Subject: Duke Energy Corporation  
Oconee Nuclear Station - Units 1, 2, and 3  
Docket Nos. 50-269, 50-270, and 50-287

Revisions to Topical Report DPC-NE-3003 In Support of  
Steam Generator Replacement  
Response to NRC Staff Request for Additional  
Information

Enclosed herein, please find the Duke Energy Corporation (Duke) response to the May 12, 2003 NRC staff's request for additional information concerning topical report DPC-NE-3003, Revision 1, "Mass and Energy Release and Containment Response Methodology."

### **Duke Power Response To Request For Additional Information**

**GOTHIC 7.0 - FATHOMS COMPARISON**  
**ROTSg STEAM LINE BREAK**  
**(1.4 ft<sup>2</sup> Break)**

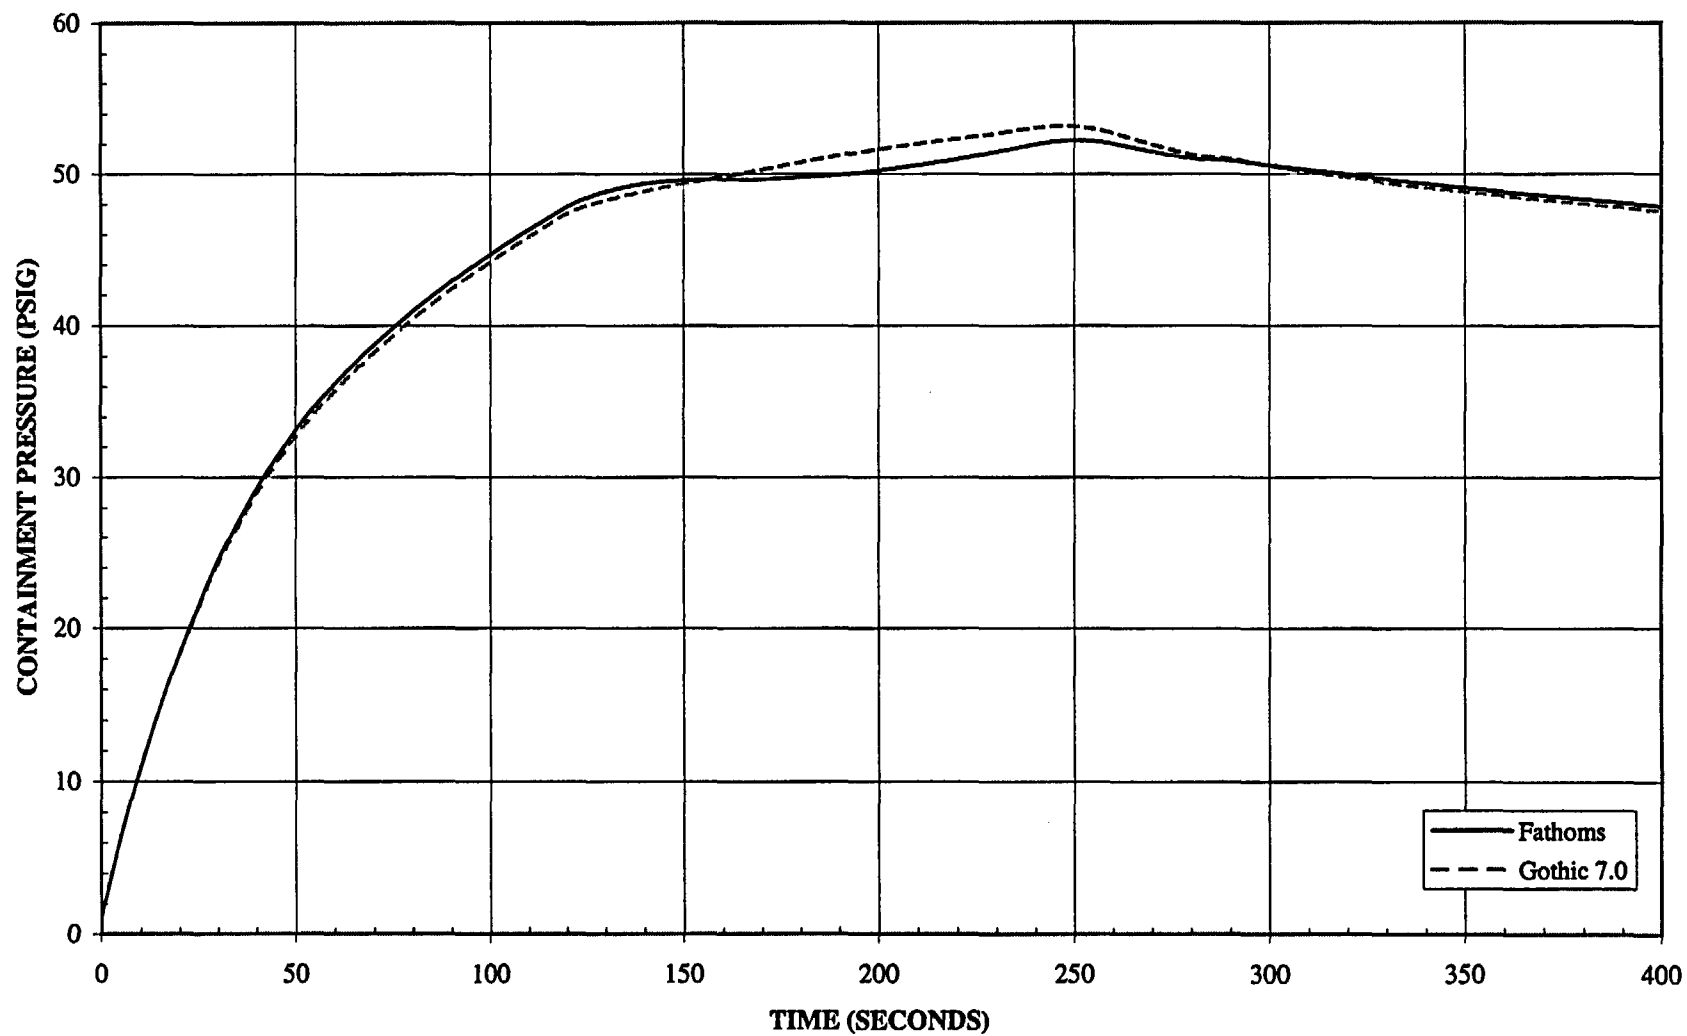
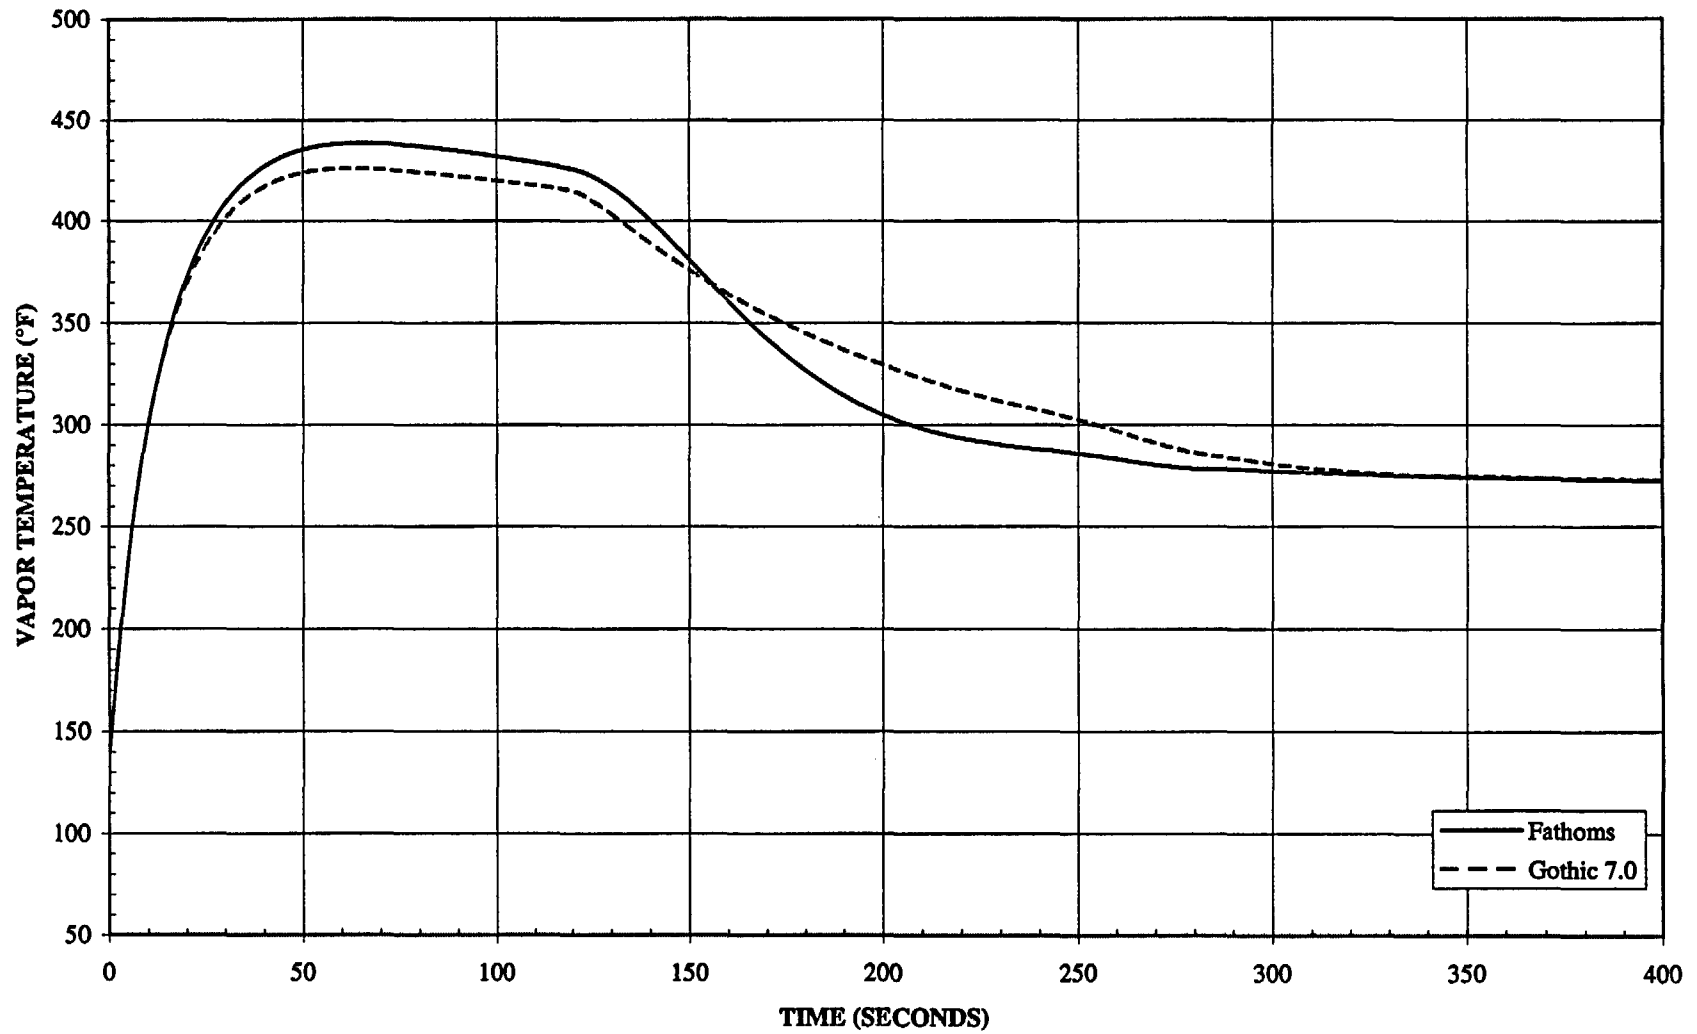
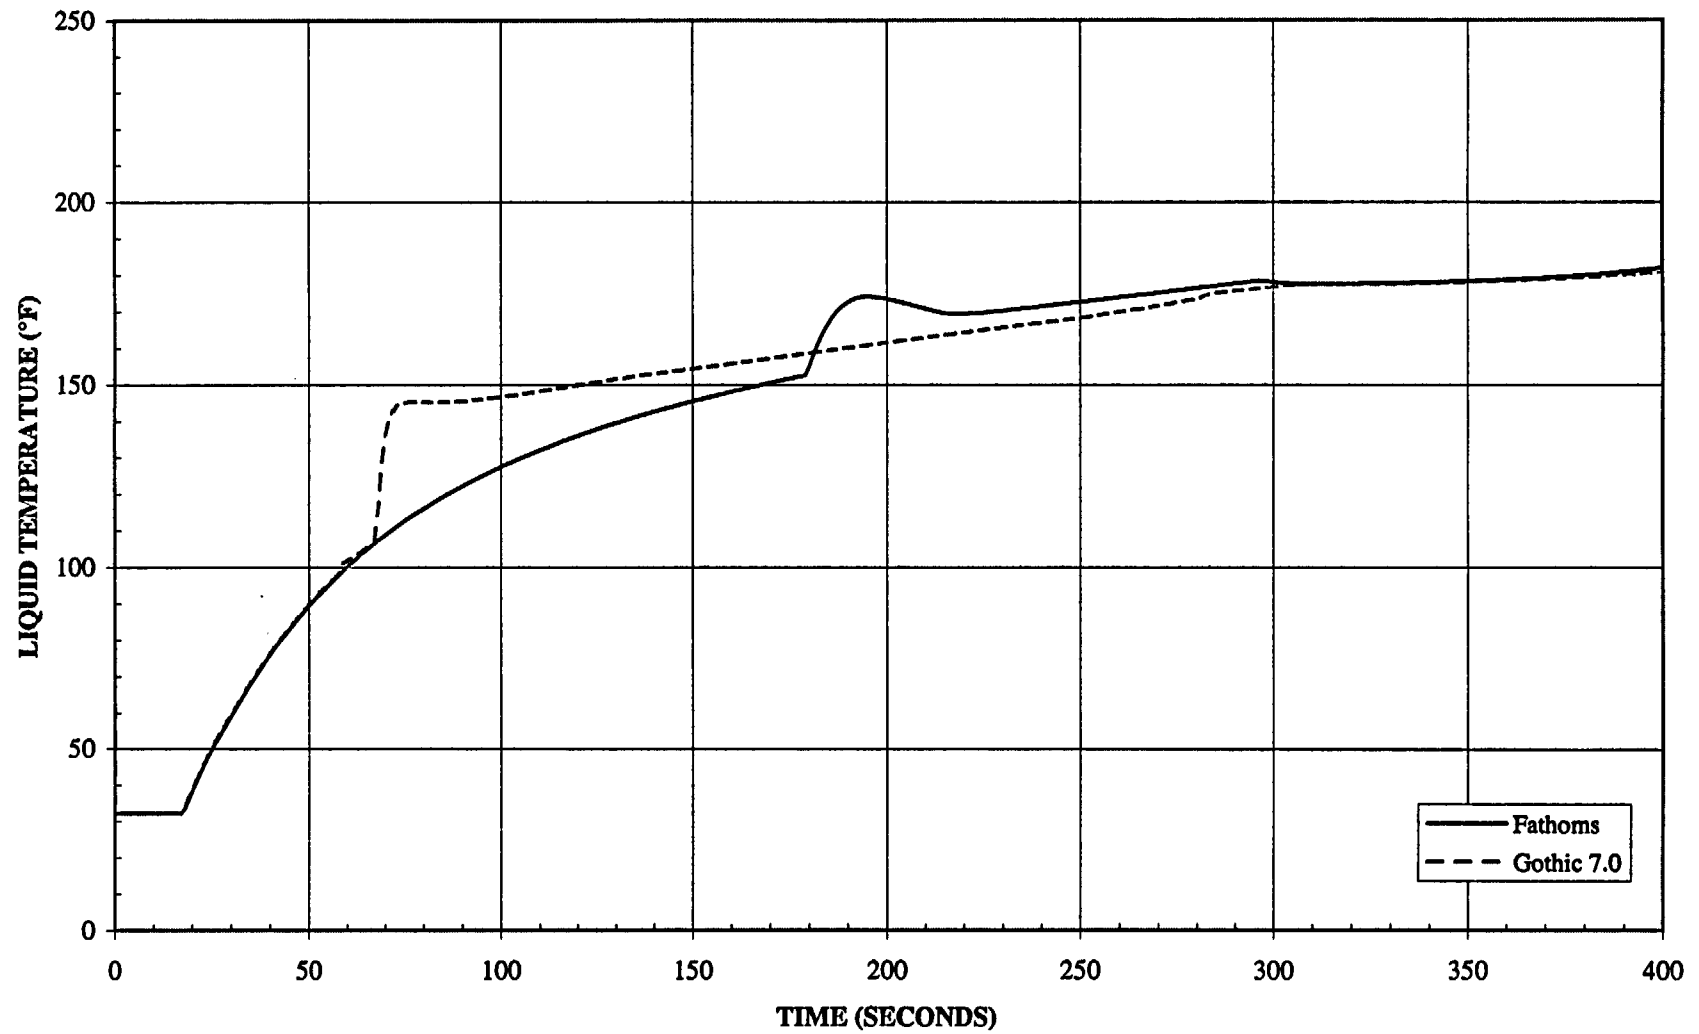
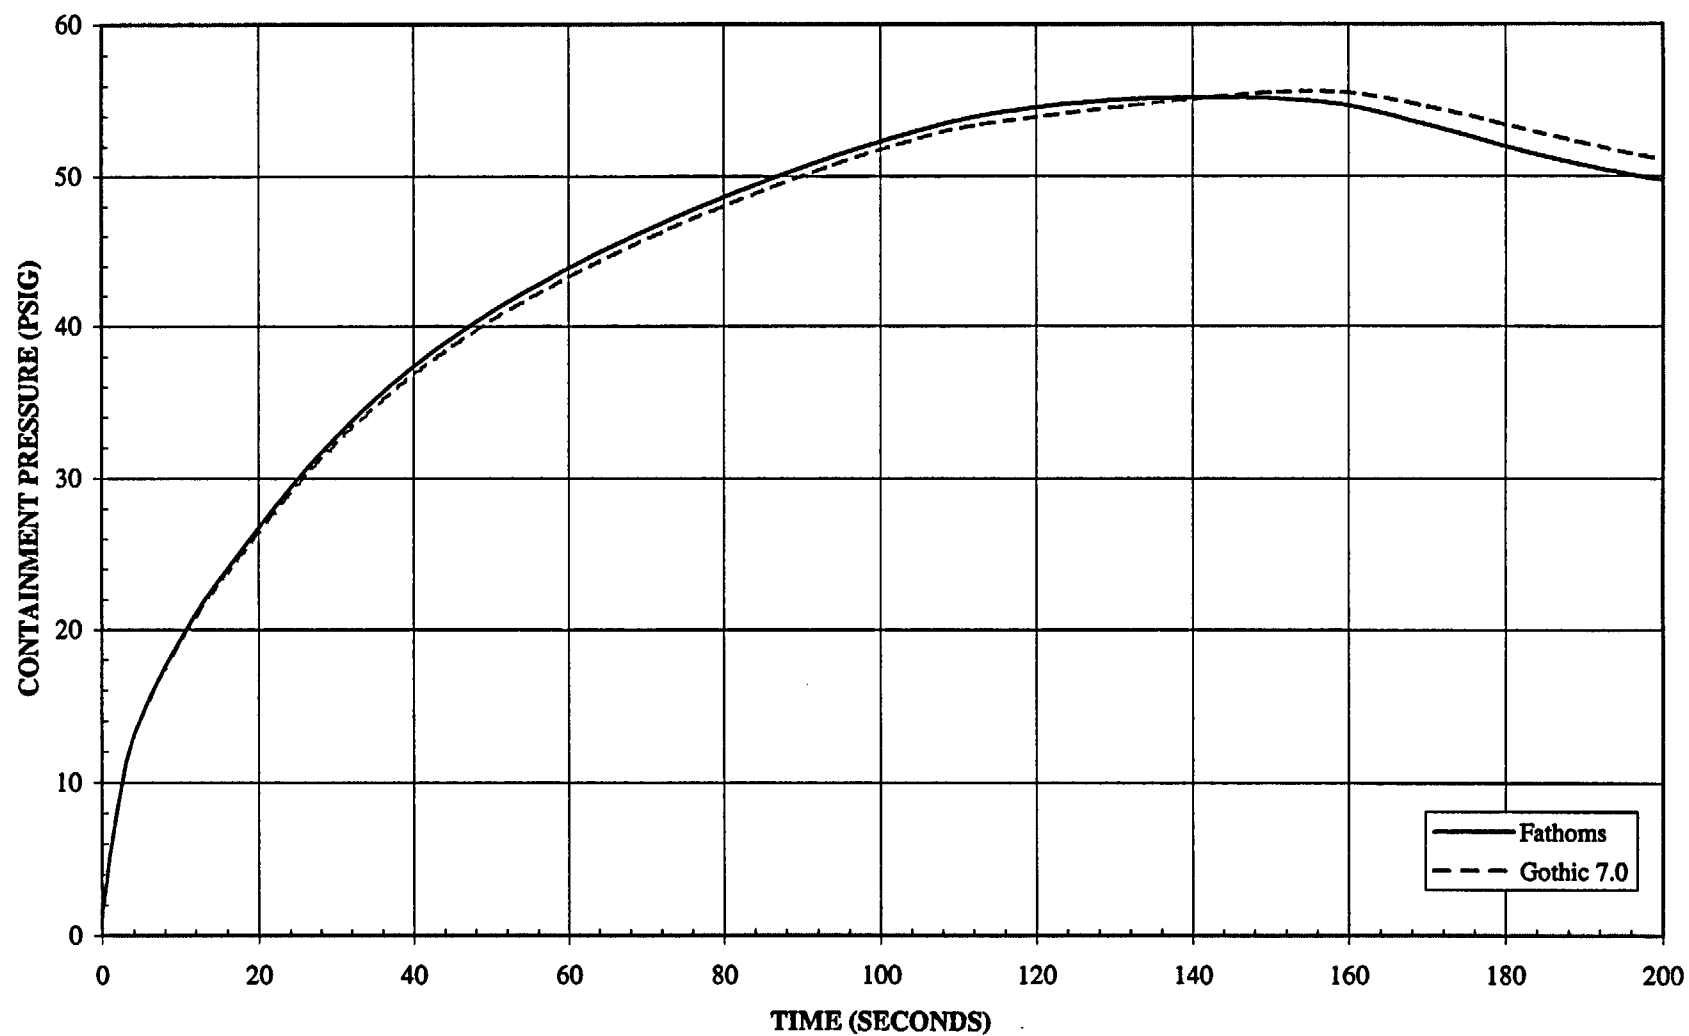
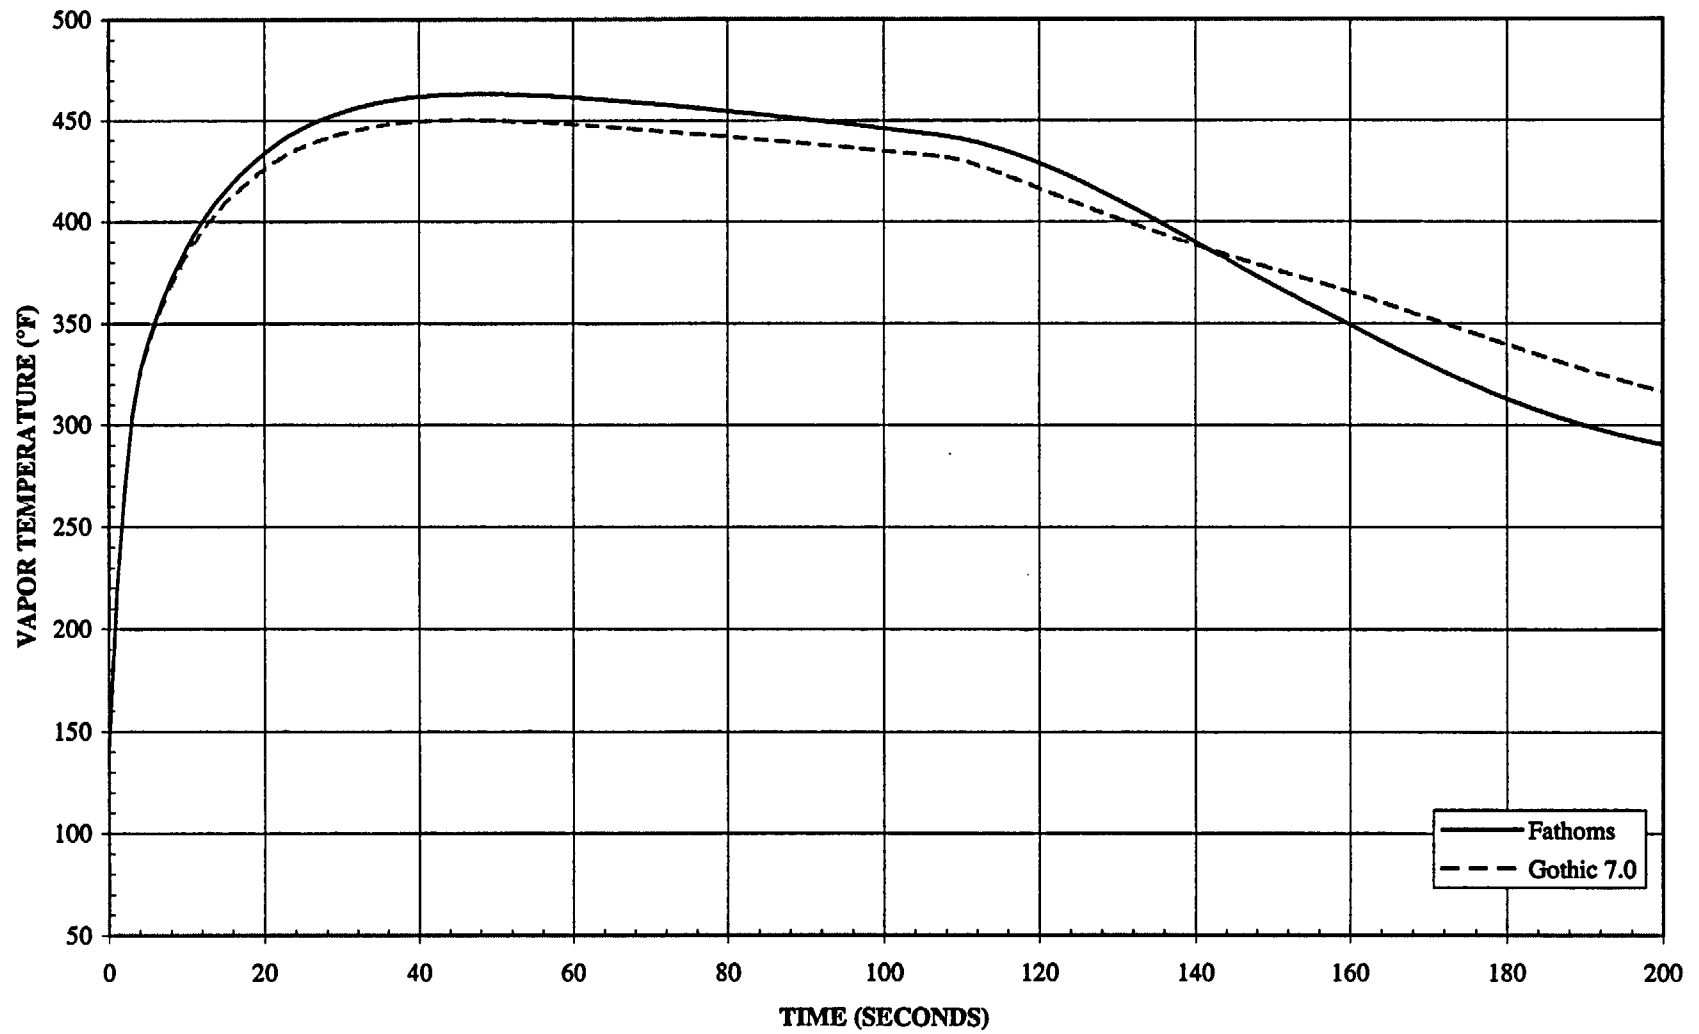
14. Show that GOTHIC and FATHOMS calculations result in the same pressures, temperatures, sump temperatures, etc. for the design basis LOCA and main steam line break events. If they do not, explain differences in terms of the differences in models between the two codes. (See Question 1.)

Response: Refer to the response to Question #3 for LOCA. The results of the 6 code comparison analyses for the main steam line break are given in Table 14-1 and the figures that follow. The containment response following a main steam line break event for the ROTSG was performed to compare the results from FATHOMS 2.4 and GOTHIC 7.0. In general, the pressure and vapor temperature responses are very similar. GOTHIC 7.0 predictions for peak pressures are slightly lower on the smaller break sizes (~0.3 psi) and slightly higher for larger break sizes (~0.95 psi). The peak vapor temperature responses predicted by GOTHIC 7.0 overall are slightly lower (~12°F). For larger break sizes, the higher pressure predicted by GOTHIC 7.0 may be attributed to additional steam generation from the improved interface heat and mass transfer models and from the drops that are generated due to dripping. The slightly lower pressure for smaller break sizes may be attributed to additional droplets in the atmosphere. The slightly lower vapor temperature and liquid temperature in GOTHIC 7.0 for all break sizes may be attributed to additional droplets in the atmosphere also. This effectively increases the heat capacity of the atmosphere and reduces the temperature rise for a given energy addition. As discussed in the responses to Questions #1 and #3, more liquid is predicted to remain in droplet form in GOTHIC 7.0 which results in less liquid mass in the sump. In addition, the lower sump temperature predicted by GOTHIC 7.0 may be attributed to the addition of the second energy equation for the drops and the improved heat and mass transfer models in GOTHIC 7.0.
